APPLICATION FOR APPEAL

FIRE INSPECTION CORRECTION NOTICE

RE: 497 OTIS AVE
Residential Class: C

Items for Appeal on the Fire Inspection Correction Notice "Deficiency List"

2ND FLOOR
GUARD RAIL

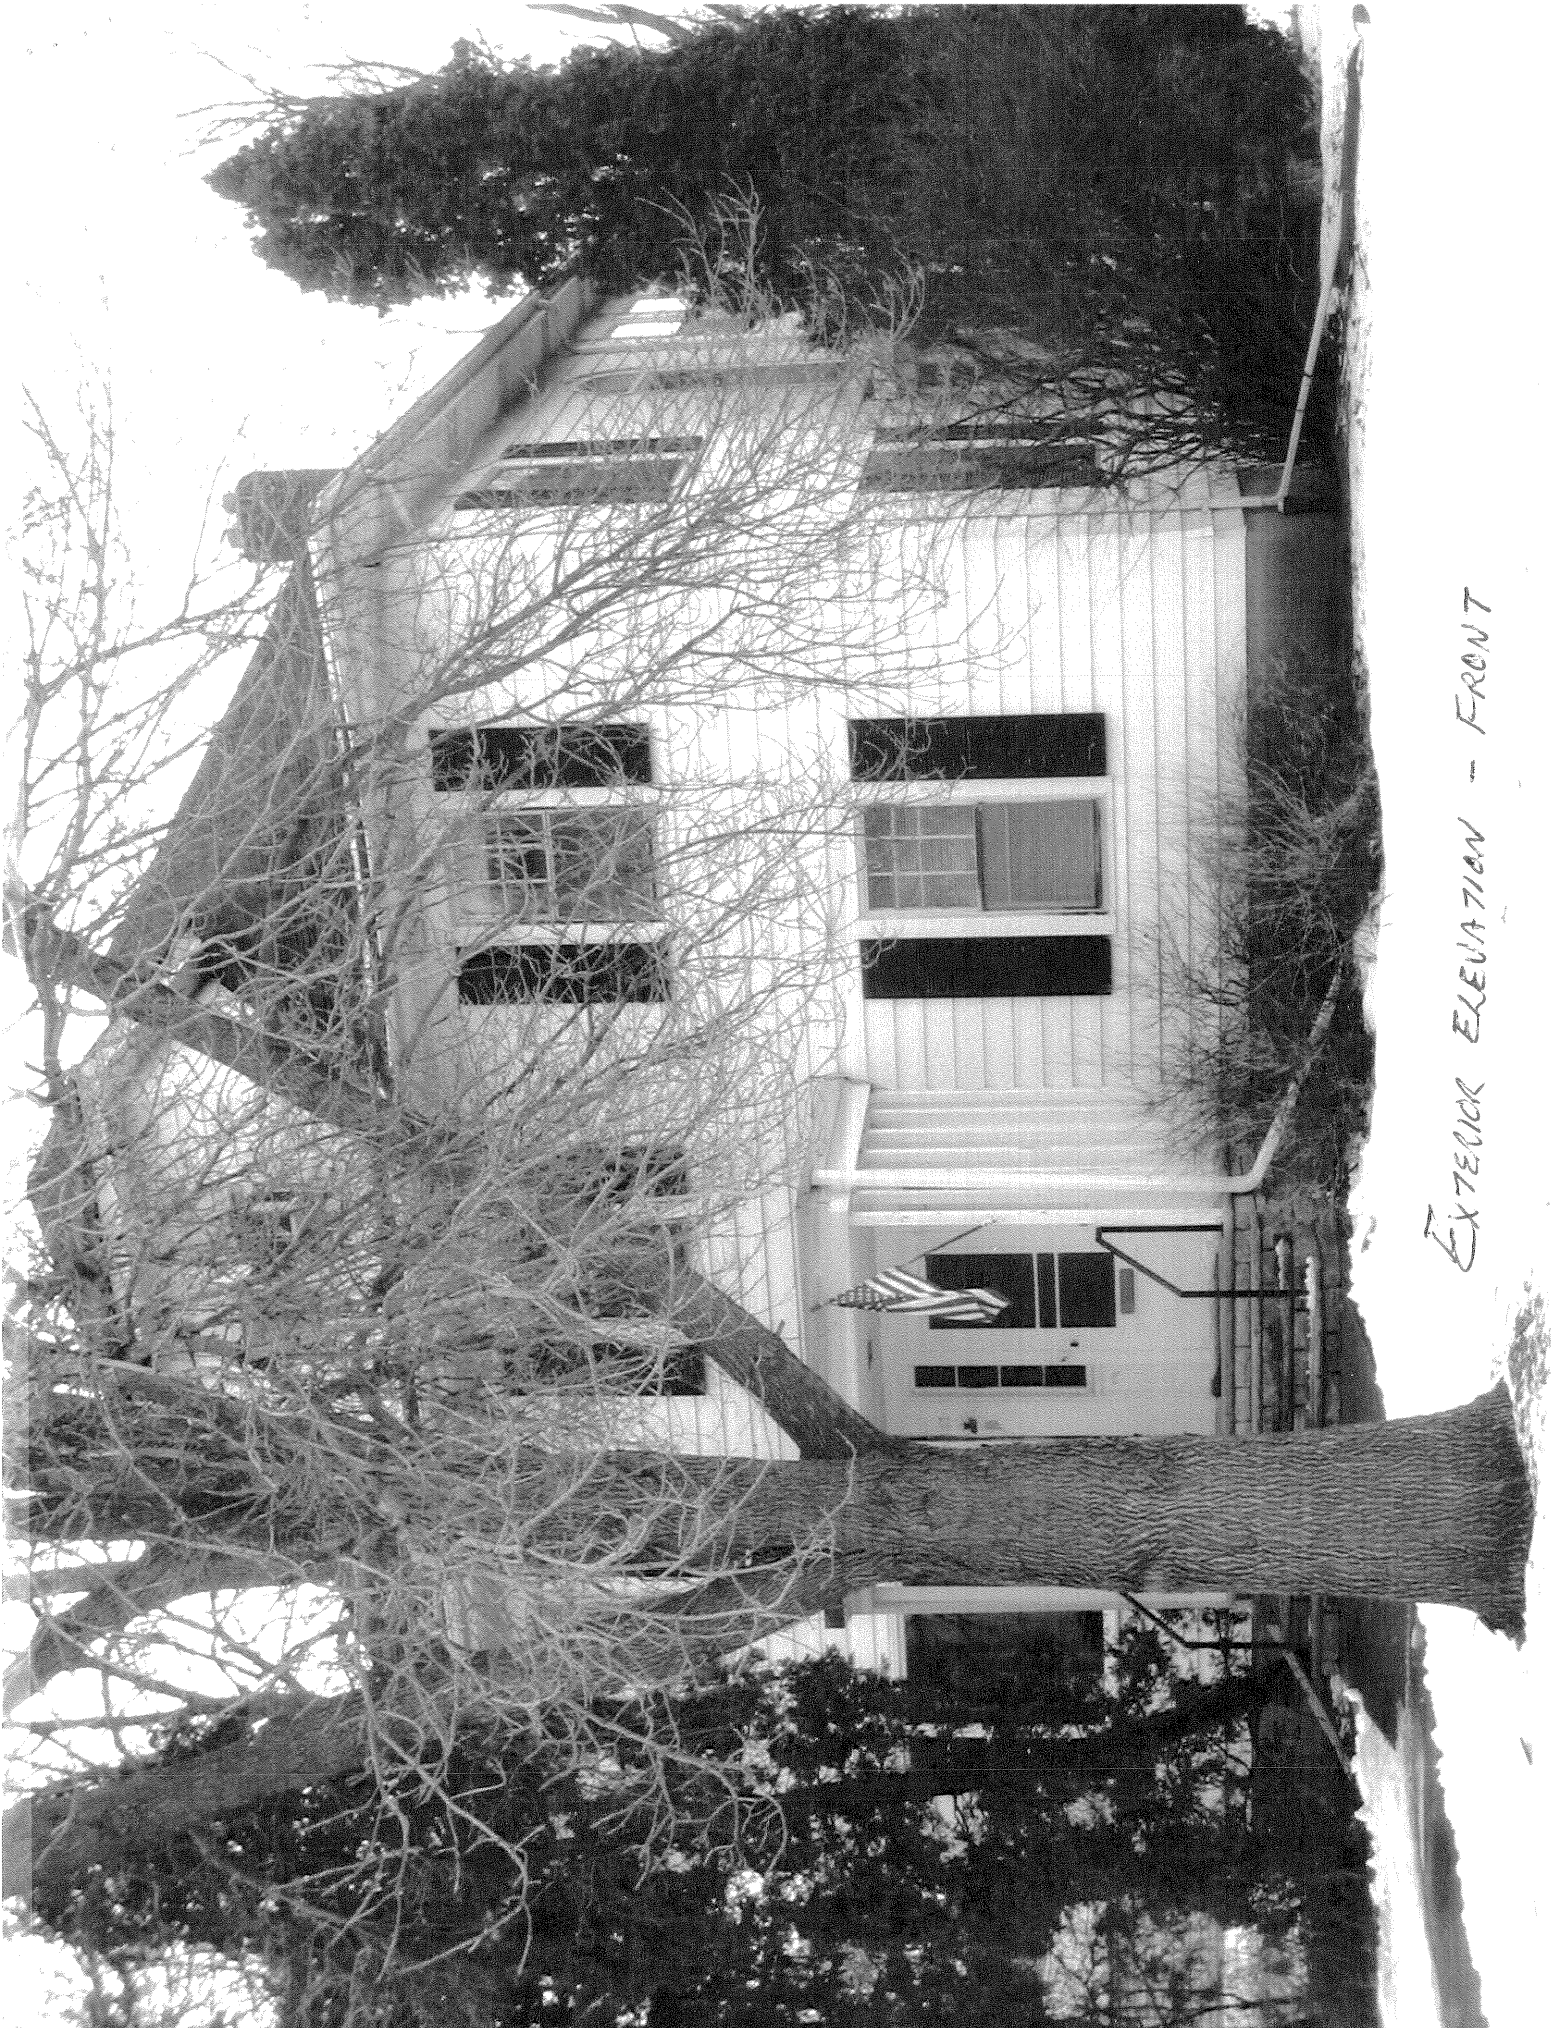
4. Garage and behind gas range - MSFC 605.6 - Provide electrical cover plates to all outlets, switches and junction boxes where missing.
5. Second and third floor stairways - SPLC 34.10 (3) 34.33(2) - Provide an approved guardrail. Intermediate ballustrade must not be more than 4 inches apart. Intermediate rails must be provided if the height of the platform is more than 30 inches.-Current guardrails are 29.5 inches.
6. Throughout - MN Stat. 299F.362 - Immediately provide and maintain a smoke detector located outside each sleeping area.-Maintain hard wired smoke detectors in an approved manner.

Fire Inspection Deficiency List Item 5....2nd and 3rd Floor Stairways

Sec. 34.10 (3) a. states, "Every stairwell must be maintained in accordance with the building code which was in effect when the stairs were originally constructed." This building is approximately 90 years old and has been very well maintained including the stairways.

The building has a flowing coherent architecture wherein the guardrail matches the stairwell window in style and finish. The decorative period guardrail is 30.5" above the hardwood floor deck. It is located in a very wide hallway brightly lit by a chandelier directly over the guardrail plus a huge window on the landing. (See Photo)

The third floor stairway guardrail is 29 ½ " above the hardwood floor in a very low traffic area where essentially no activity takes place and thus presents very limited exposure to anyone being careless enough to fall over the rail. (see photo)

I respectfully request that the railing be allowed to remain "as is" to function effectively as it has for the last 90 years and I will continue to maintain it in a sound condition.

I would request that this rail also be allowed "as is" with continued maintenance to maintain its current sound condition.
